**RESPONSES FROM HYDRO-QUEBEC DISTRIBUTION TO THE REQUEST FOR
INFORMATION no. 1 FROM GRAME**

I. Request Bearing on the Distributor's Proof

Figure 1: Main Functionalities Used beyond Remote Meter Reading

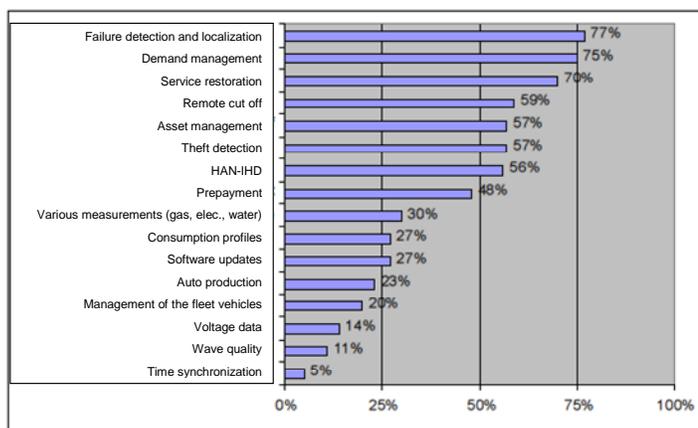
18. The Distributor clarifies in its proof (HQD-1, Document 1, page 17) that the technology selected will allow for the implementation of new functions. In Figure 4 (HQD-1, Document 1, page 18), a list enumerates the main functions used in addition to remote meter reading. Among these functions appears “Management of a fleet of vehicles.” Does this involve electric vehicles?

Yes.
